**ADDENDUM 2**  
to the  
**BIDDING DOCUMENTS**  
for

**ADRIAN PHILLIPS THEATER RENOVATION**  
**Boardwalk Hall**  
**Atlantic City, NJ**

**October 19, 2017**

**A1.3**

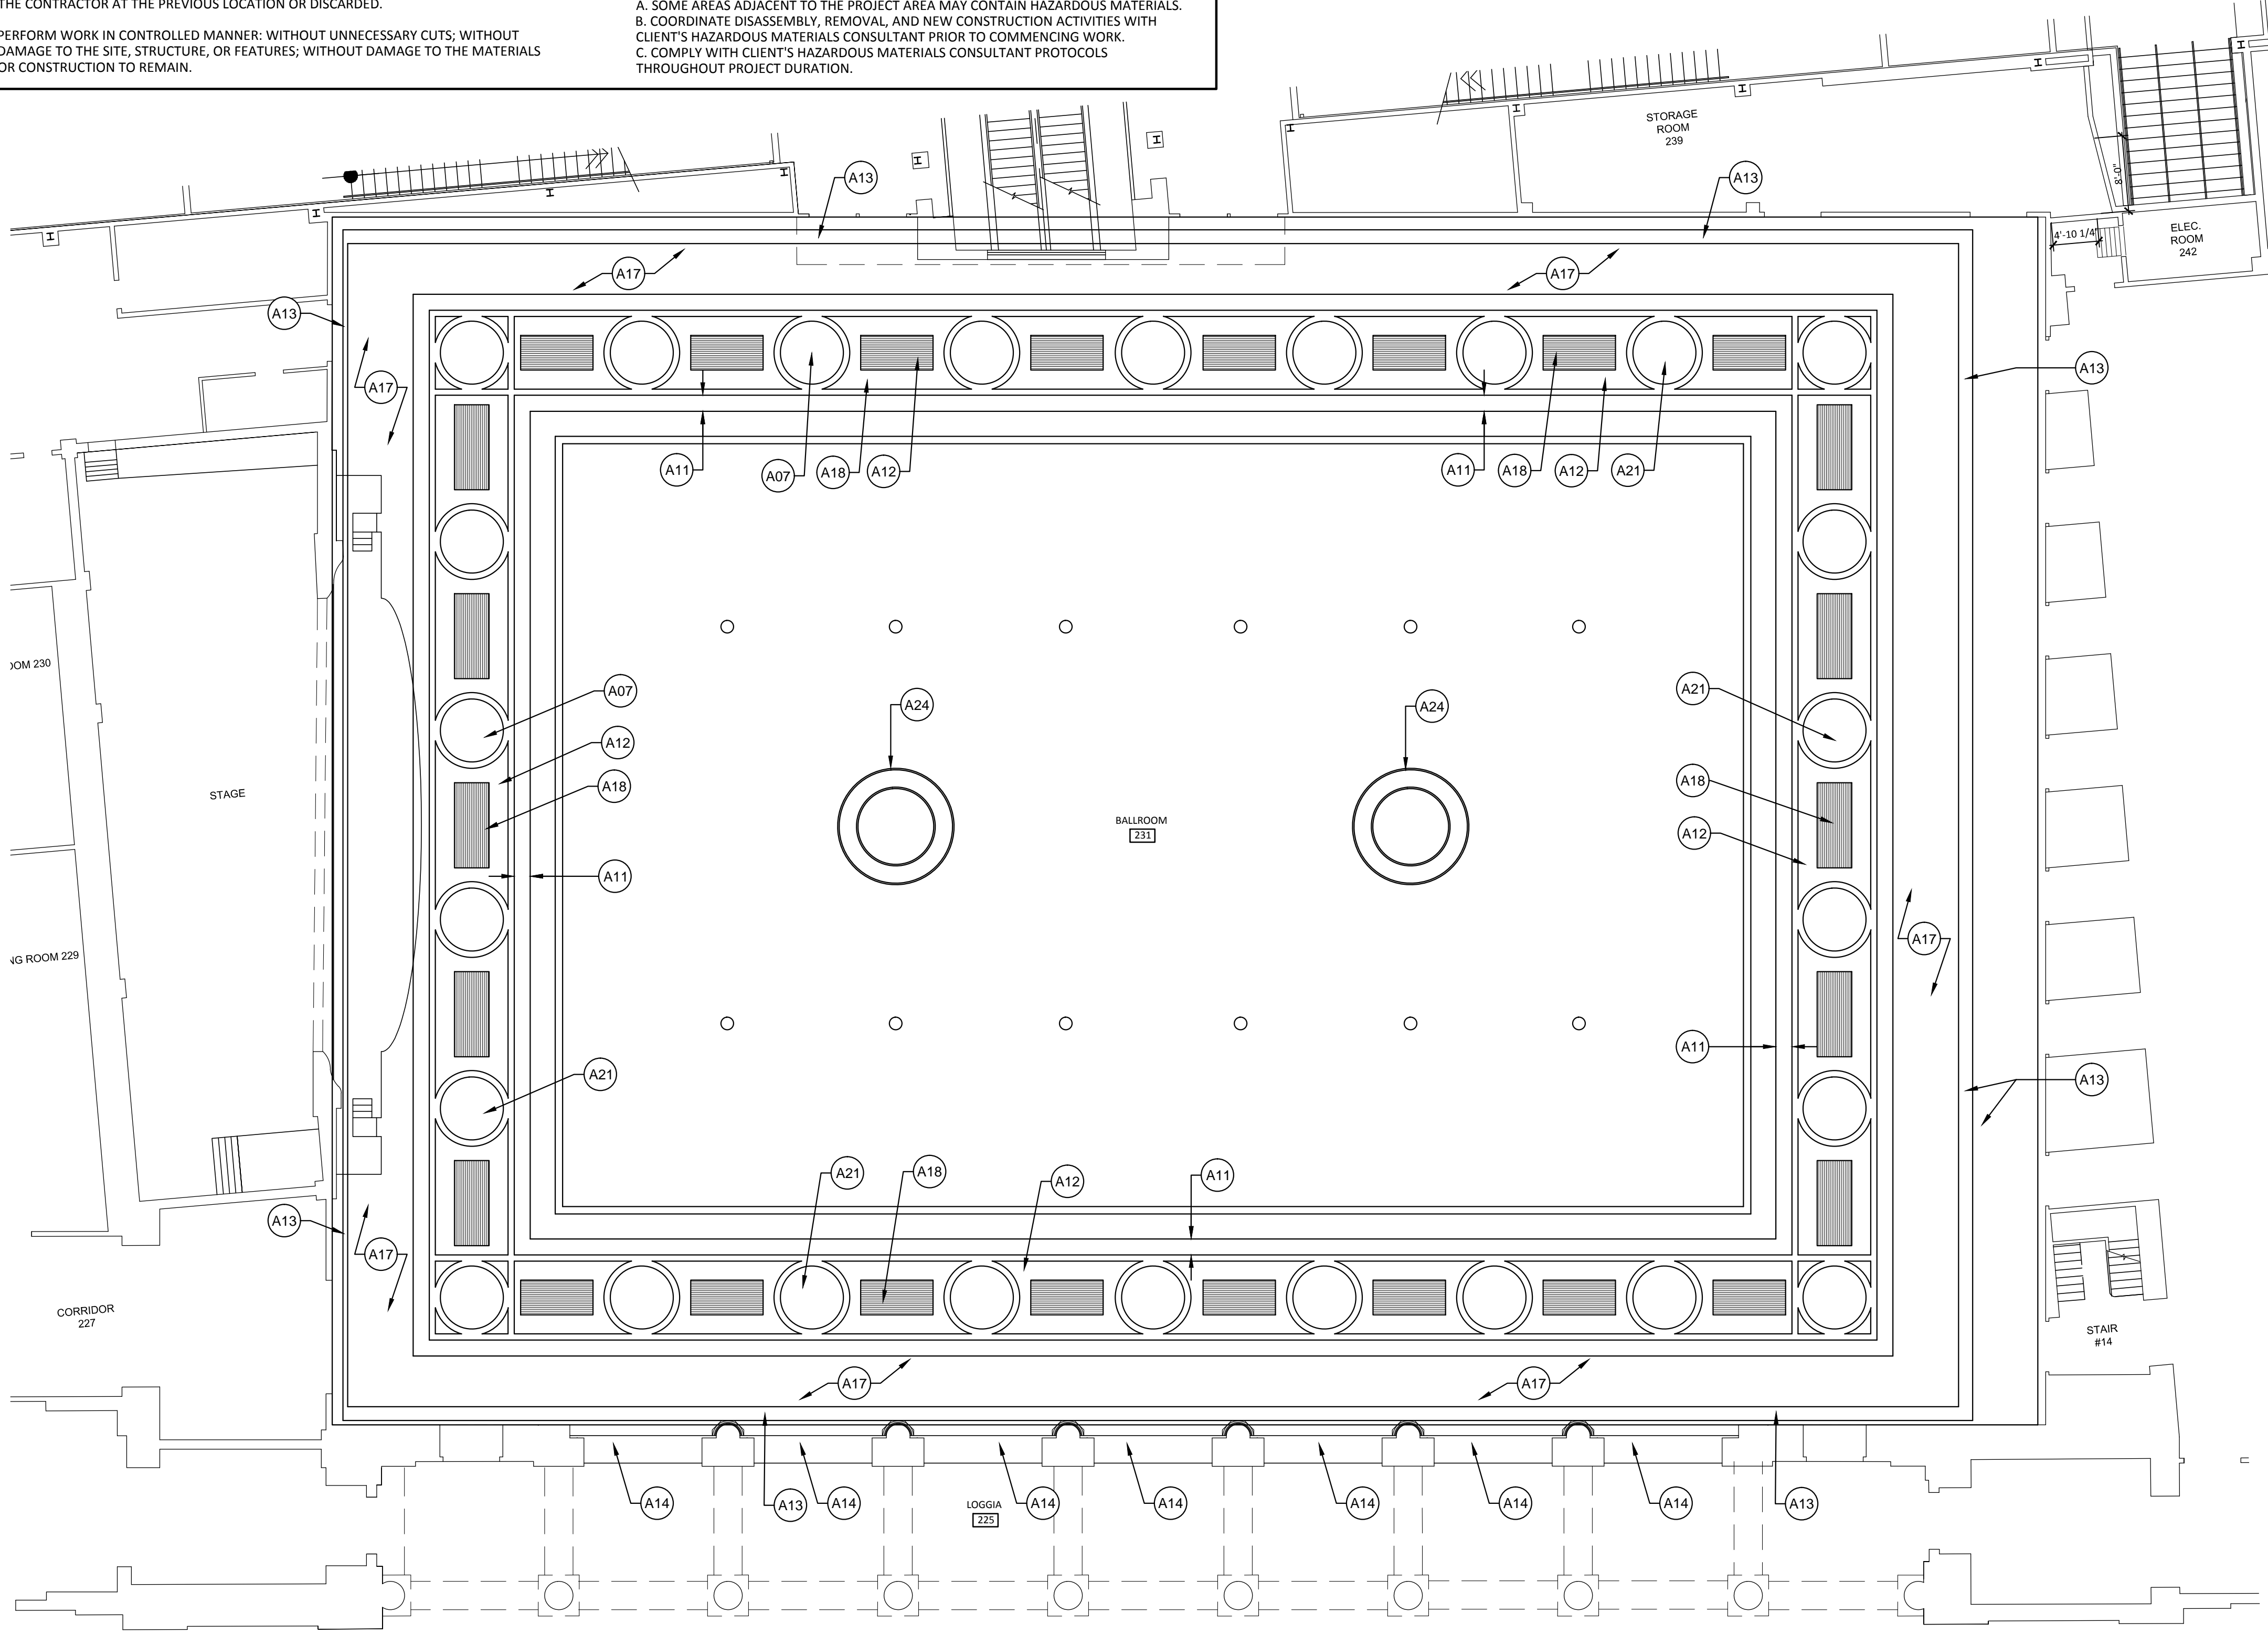
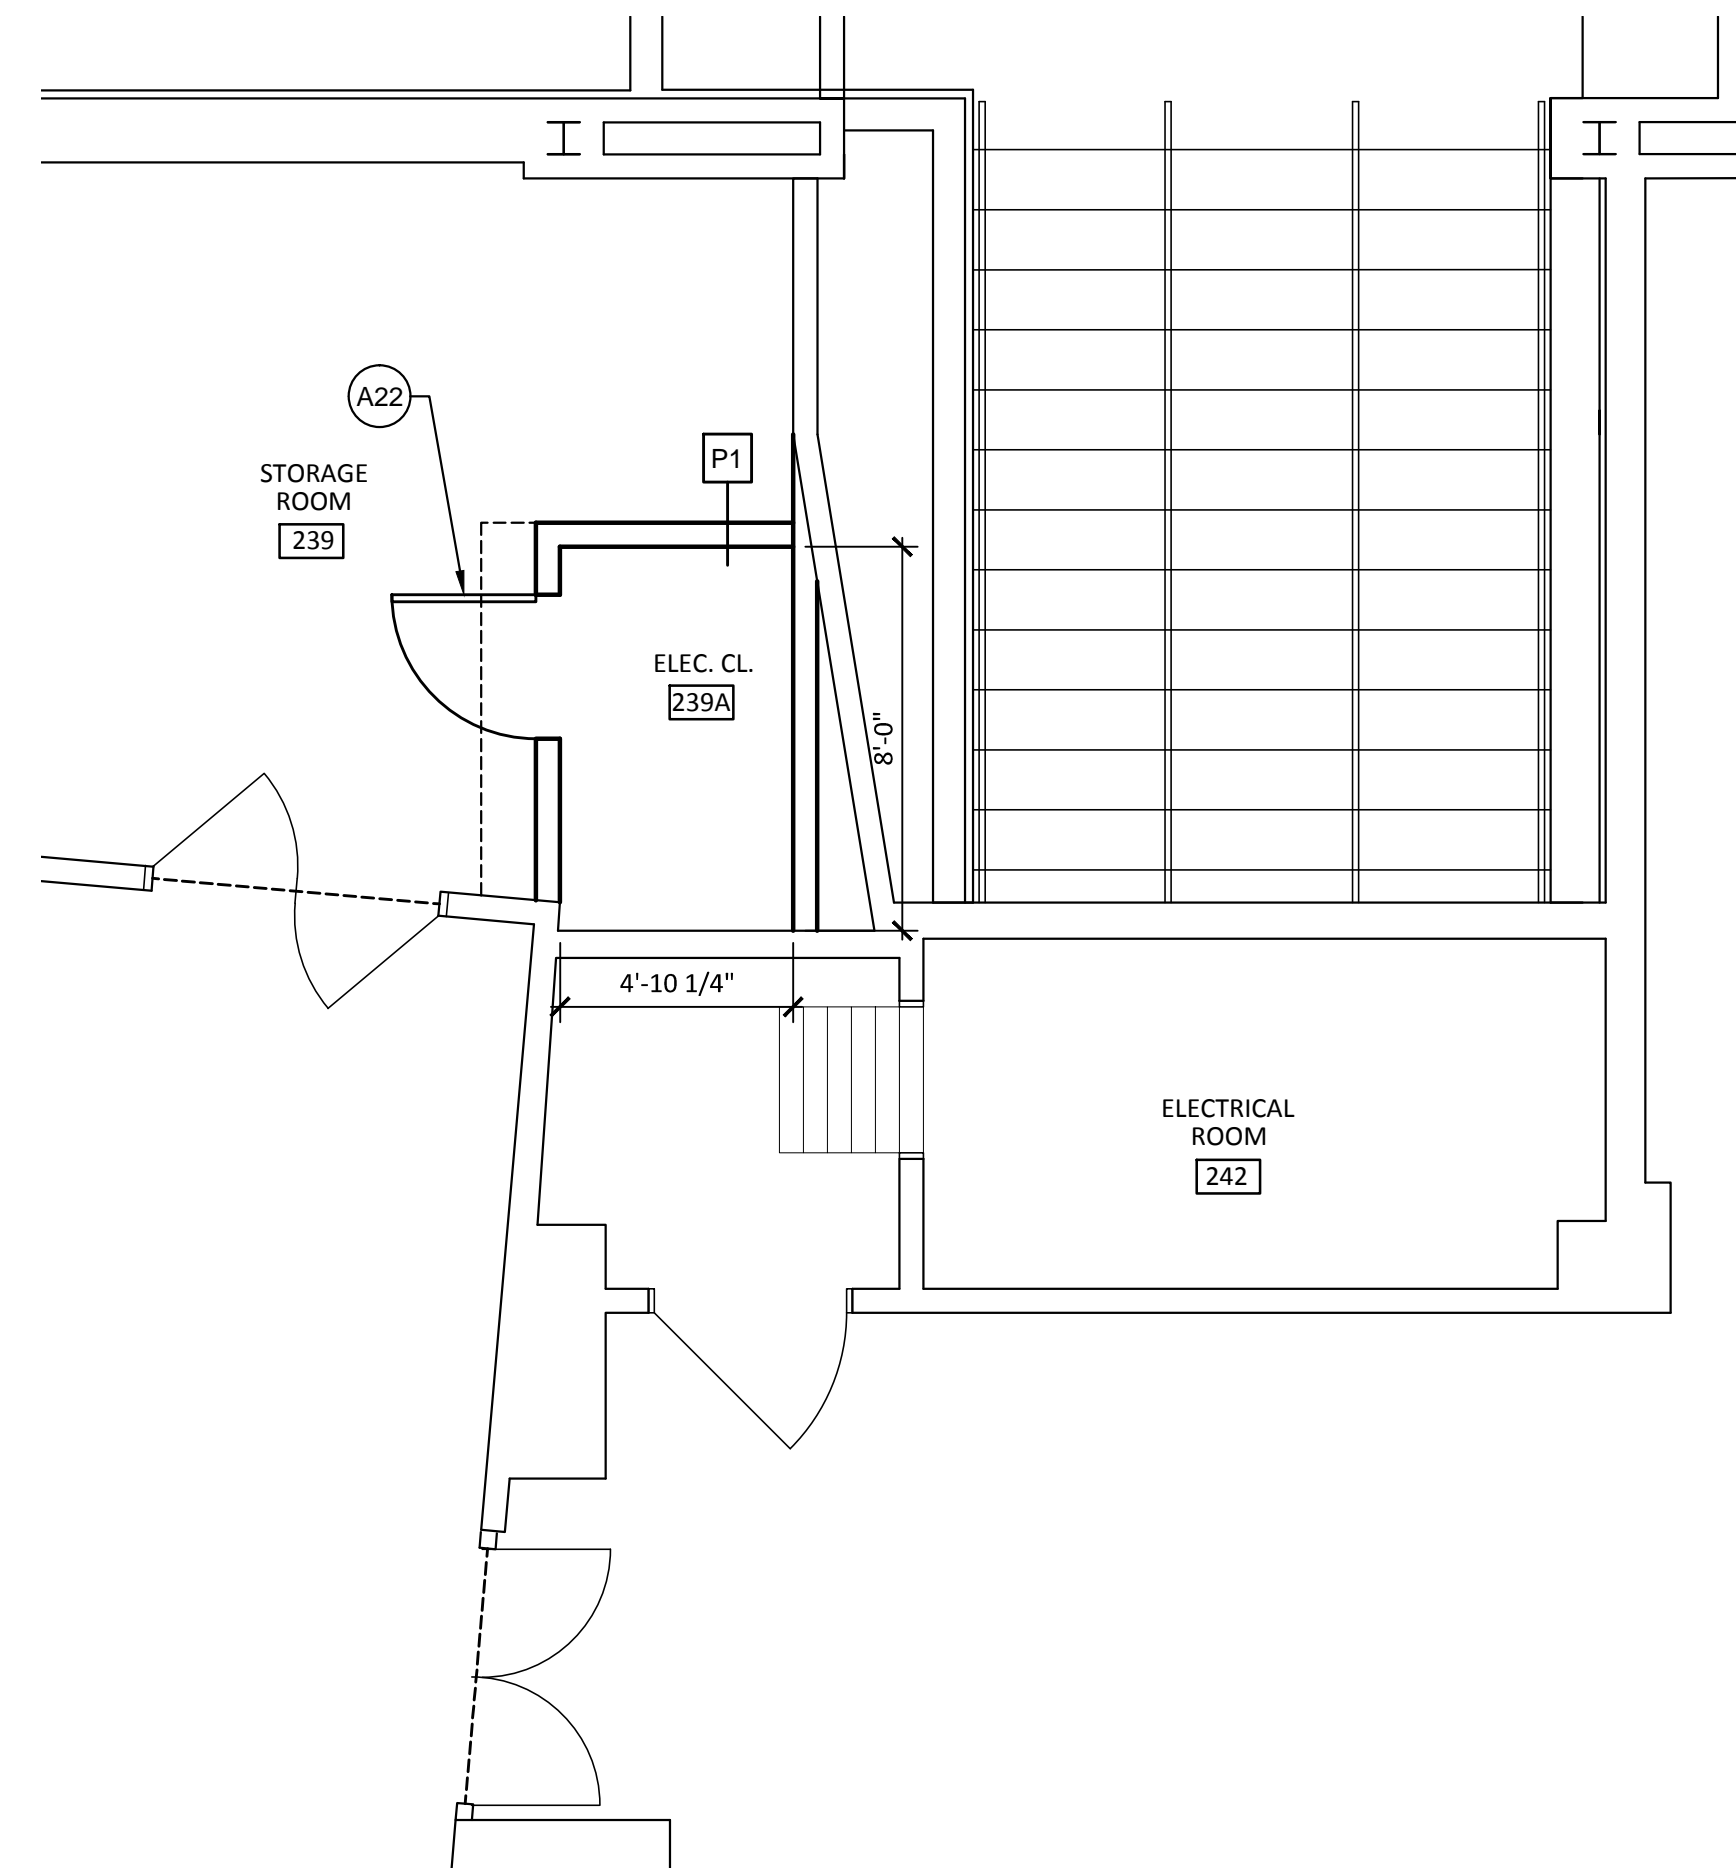
**QUESTION 16.** Sheet A1.3 shows one door and frame tied to note A22, and a wall that is shown on sheet A0.1 as fire rated. If this wall is fire rated does the door and frame need to be fire rated?

**A1.4**

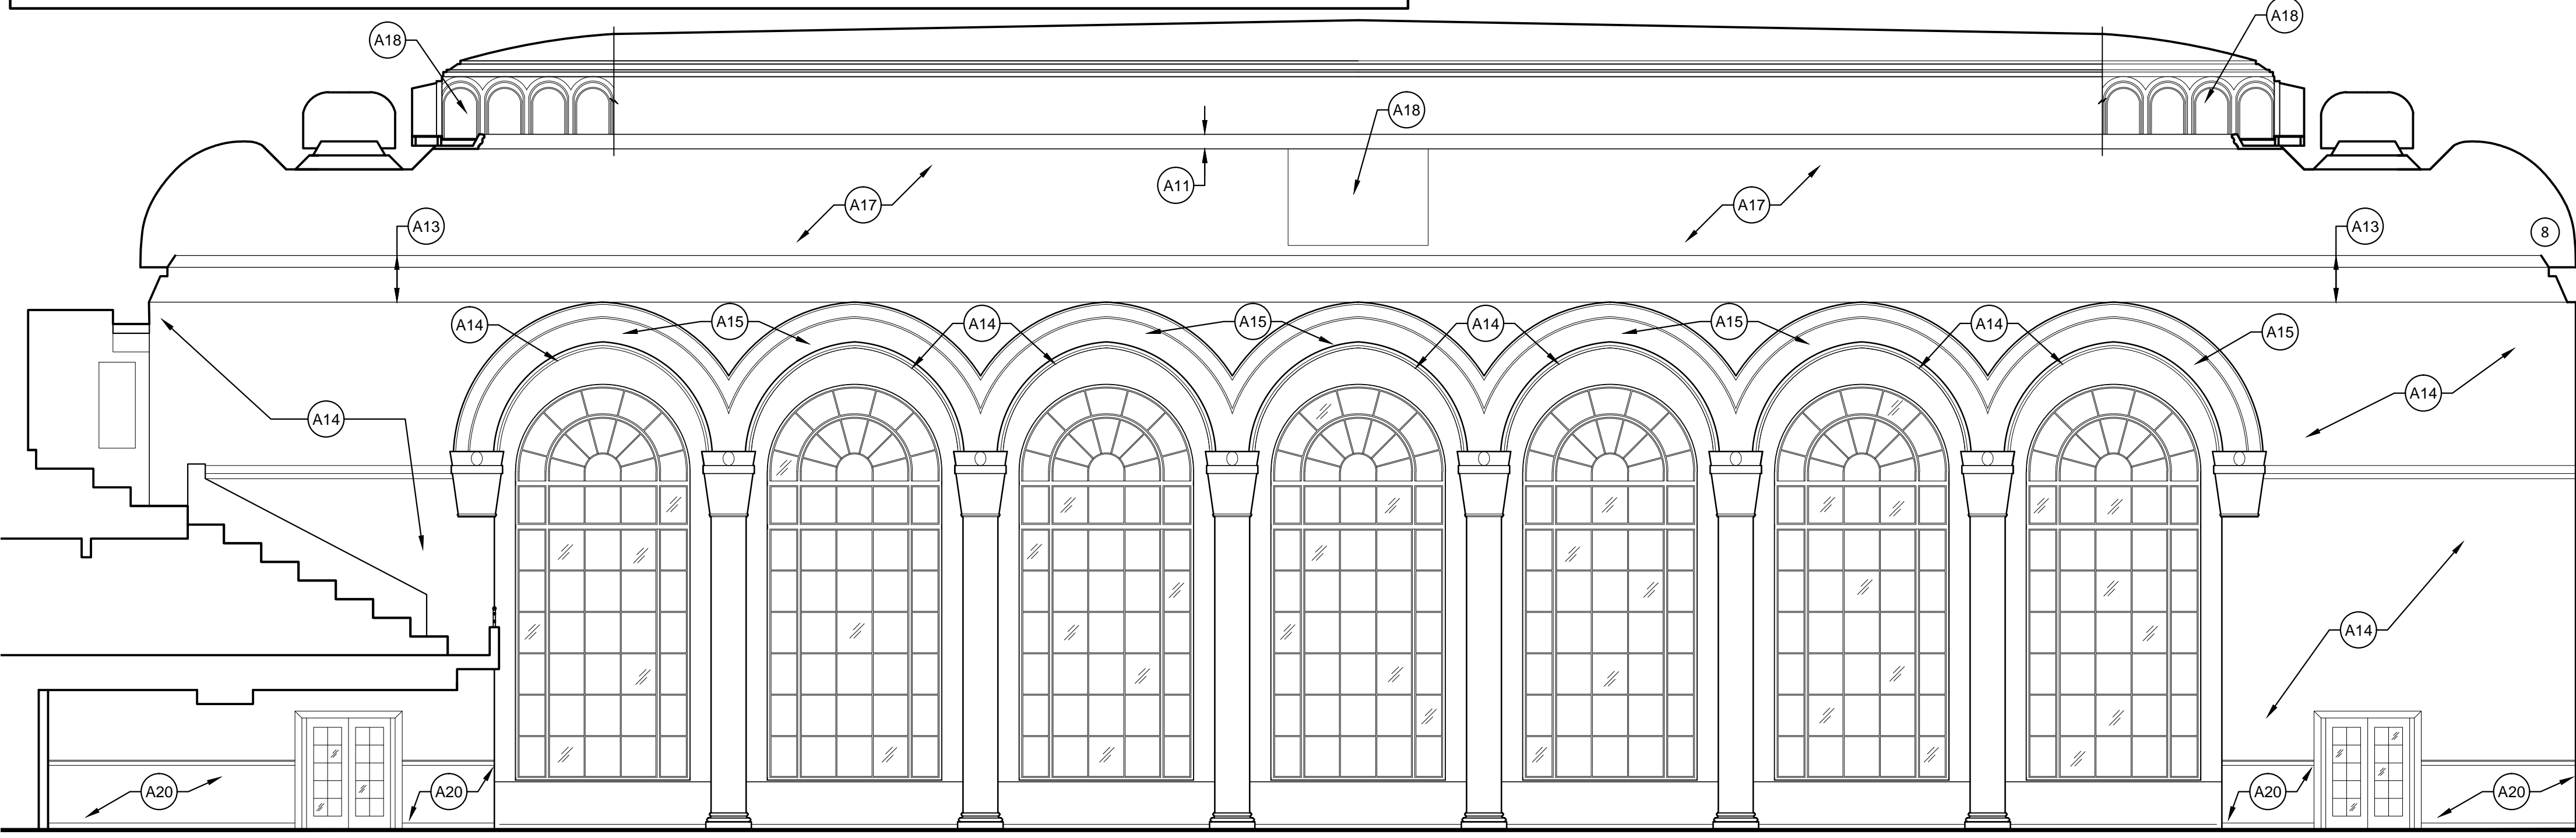
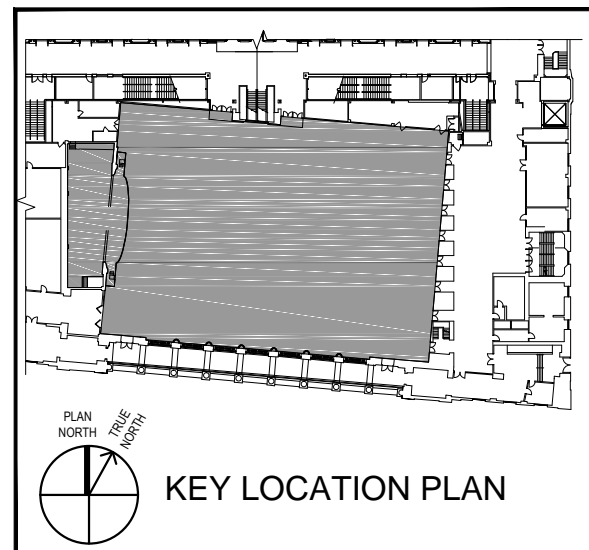
- B. Drawings A1.1, A1.2, A1.3, A1.4:
  - 1. A0.3: Scale correction
  - 2. Change to Construction Key Notes: A09-A, A14, A17, AND A21

**QUESTION 2.** Note A21 on sheet A1.4 calls for ‘new sheet metal reflectors in oculi refer to electrical drawings, details, and specifications’. The details on sheet E5.1 for those fixtures and the schedule on sheet E6.2 do not show this work, and there are no references in the specifications. What are the details and requirements for these new sheet metal reflectors?

*Omit sheet metal reflectors.*
